FILE NAME										c:\pw_workdir\jacobs-americas\d0247120\XE3476_PS_TC101-1.dgn												<div>SR 167 SR 161 TO SR 410 REBUILD INTERCHANGE</div>	<div>PLAN REF NO TC101-1</div>
TIME		12:20:28 PM						REGION NO.	STATE	FED.AID PROJ.NO.				<div>0167(059)</div>									
DATE		9/2/2025						10	WASH														
PLOTTED BY		graham.robinson																					
DESIGNED BY		G. ROBINSON								JOB NUMBER						<div>LOCATION NO.</div>	<div>SHEET OF SHEETS</div>						
ENTERED BY		G. ROBINSON		REV 0 - RELEASED FOR CONSTRUCTION		09/02/25				CONTRACT NO.													
CHECKED BY		R. MILLER		REV B - FINAL REVIEW		07/16/25				XE3476													
PROJ. ENGR.		T. SLIMAK		REV A - PRELIMINARY REVIEW		05/30/25																	
REGIONAL ADM.		S. ROARK		REVISION		DATE		BY								<div>ATKINSON CONSTRUCTION</div>	<div>Jacobs</div>	<div>LANE CLOSURE MERIDIAN VALLEY SLIP-LANE CLOSURE</div>

ATKINSON
Sept 03 2025
RELEASED FOR CONSTRUCTION

MH - TC101-1

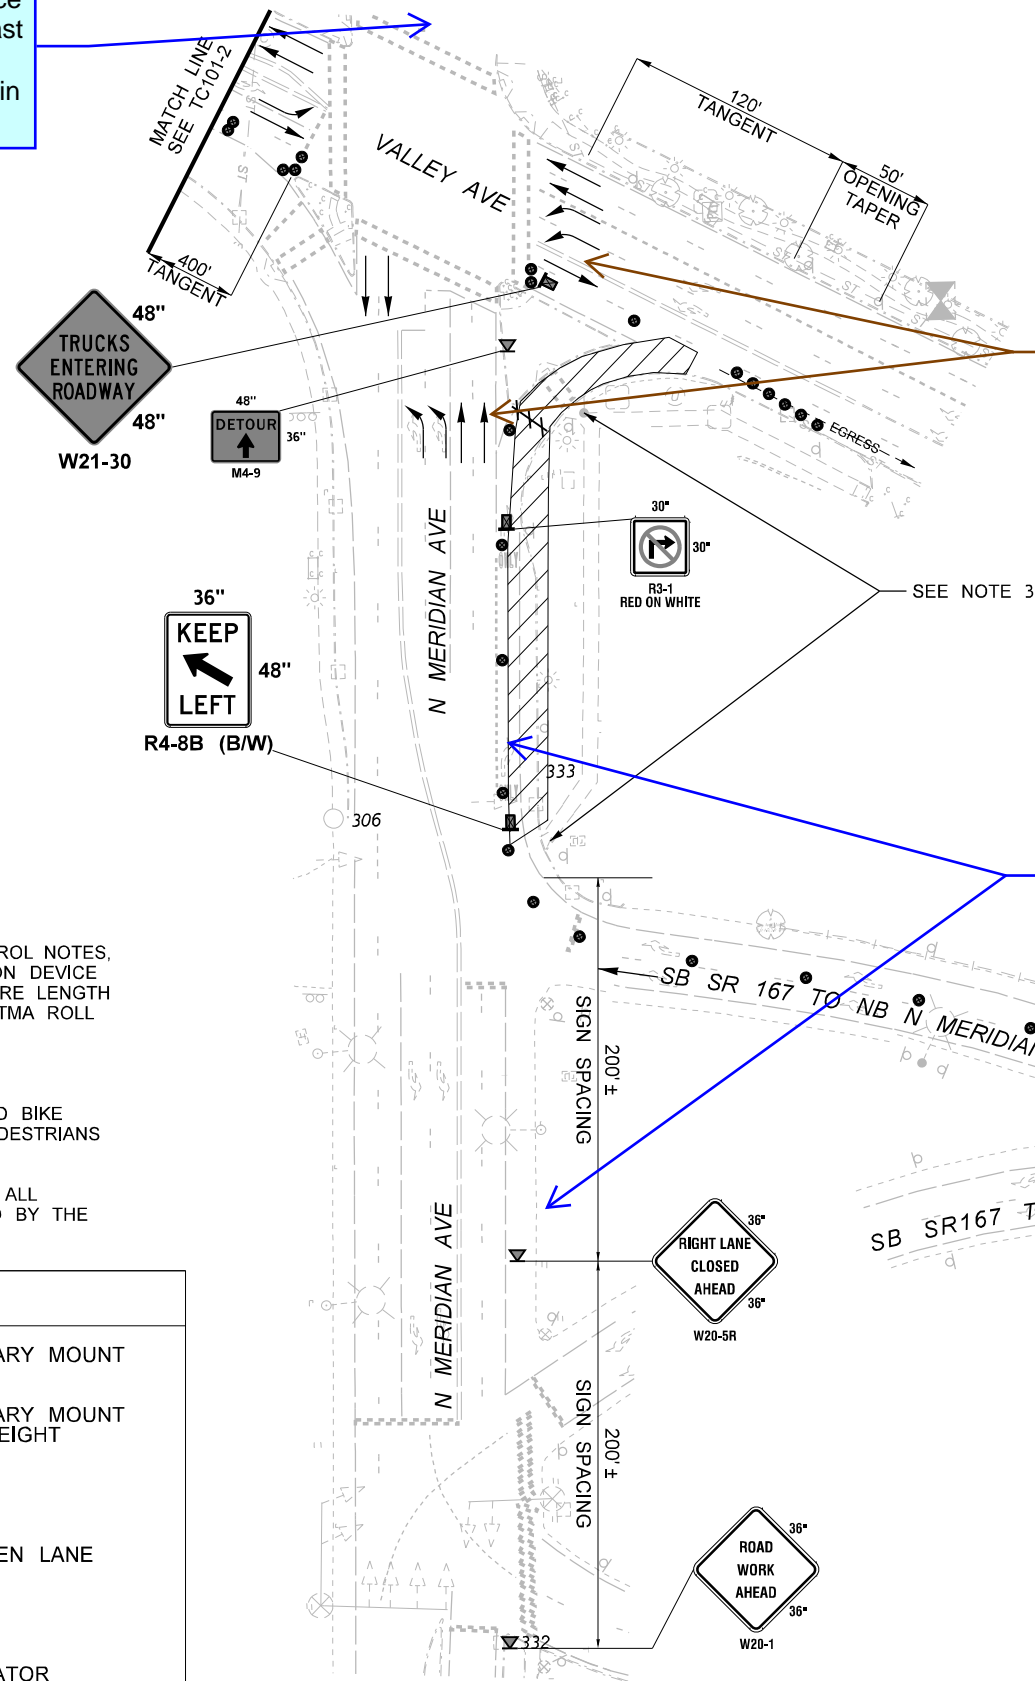
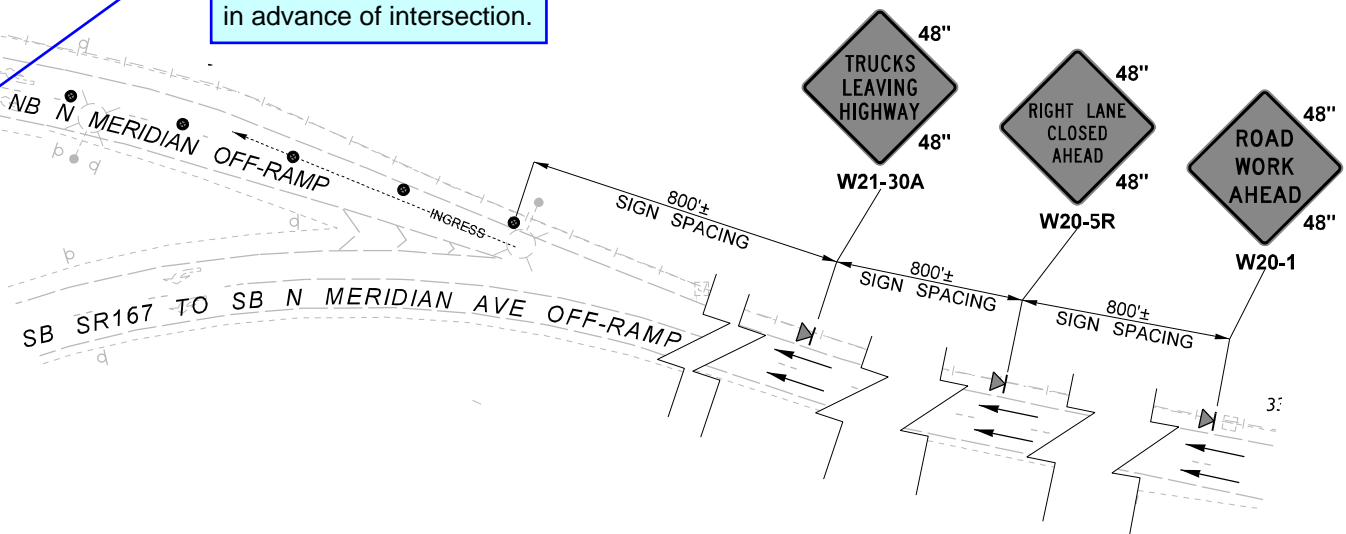
At least 72-hour advanced notice to the City is required prior to setting up traffic control and starting work. First, notify City Inspector, Michael Rosenau, at 253-344-6753. Upon scheduling an agreeable start date with Michael, notify the City's Public Works Streets Supervisor, Scott Hill at 253-841-5409 and Public Affairs Officer, Eric Johnson, by emailing him the road closure dates and times at EJohnson@puyallupwa.gov and by calling him at 253-344-6269.

The City of Puyallup does not authorize or permit work or traffic control in the Washington State Department of Transportation's right-of-way.

On or before the Wednesday prior to work commencement or traffic control, the applicant shall notify the WSDOT Area 1 Maintenance office of work on a state route (SR) at (360) 357-2600 or at orfeedback@wsdot.wa.gov. The applicant shall complete the Traffic Management Center (TMC) requirements.

Add a note on all TCP pages (or revise the first note on TCD00) stating that all TCPs and work shall comply with the final or most recently adopted Washington State Department of Transportation Maintenance of Traffic agreement for the SR 167/SR 161 to SR 410 - Rebuild Interchange Project. Furthermore, add a note that consecutive off-ramps or consecutive on-ramps shall not be closed concurrently unless approved by the WSDOT Engineer.

Portable changeable message signs shall be posted at least 72 hours in advance of work start date notifying travelers of impending road work and traffic impacts.

It may be possible to avoid the long detour on Todd RD, which is in disrepair and heavily residential, if NB vehicles are allowed to turn EB on Valley. If the inside WB-L turn lane is shut, possibly along with the NB outside lane, there may be sufficient radius for turning movements here.

Work shall immediately cease in the work zone for a pedestrian spotter, available at all times, to escort pedestrians around the work area.

Place a DETOUR AHEAD advanced warning sign for NB traffic on N MERIDIAN in advance of intersection.

Since lane closures are proposed on N MERIDIAN, N LEVEE RD, and SR 167, more than one of the WSDOT Maintenance of Traffic (MoT) sections and time tables applies to these various TCPs. Please include all applicable tables on all sheets and compare overlapping work hours. If applicable, add a note to the table indicating how many times the closure may be implemented per the MoT. Moreover, include a note that if the lane closure is adjacent to an Auxiliary Lane, the affected ramp shall be closed concurrently and the allowable hours for the ramp closure shall apply.

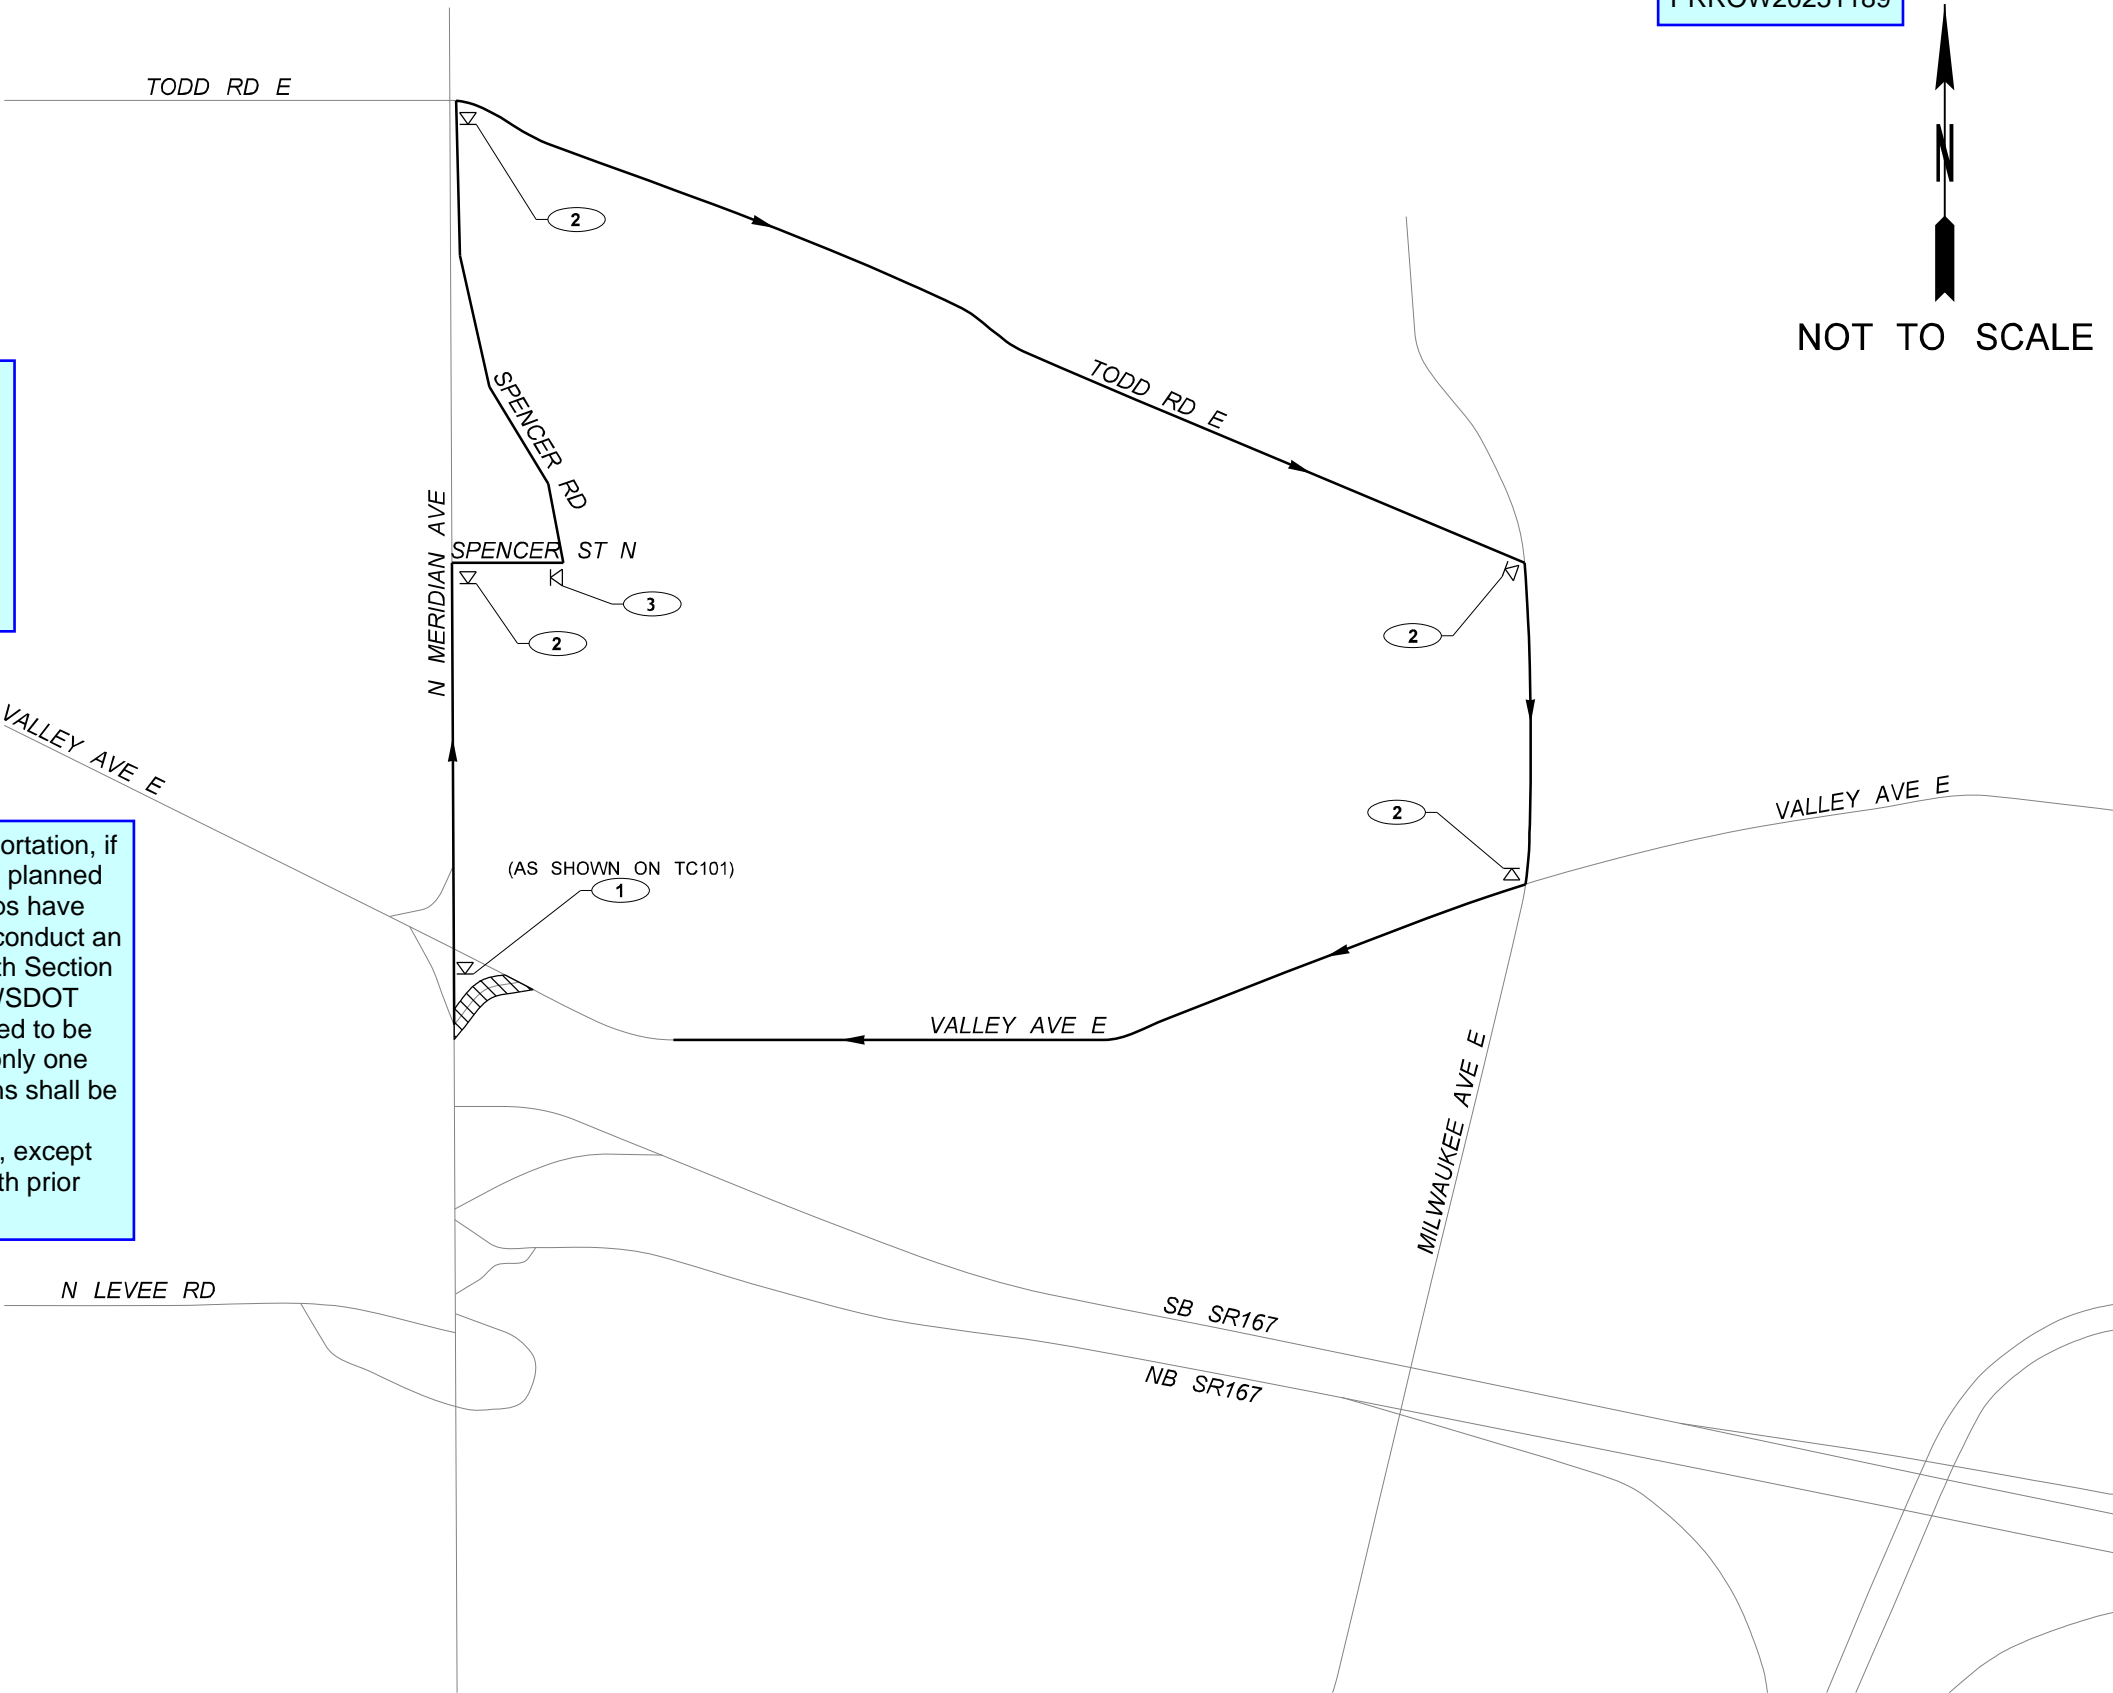
At least 72-hour advanced notice to the City is required prior to setting up traffic control and starting work. First, notify City Inspector, Michael Rosenau, at 253-344-6753. Upon scheduling an agreeable start date with Michael, notify the City's Public Works Streets Supervisor, Scott Hill at 253-841-5409 and Public Affairs Officer, Eric Johnson, by emailing him the road closure dates and times at EJohnson@puyallupwa.gov and by calling him at 253-344-6269.
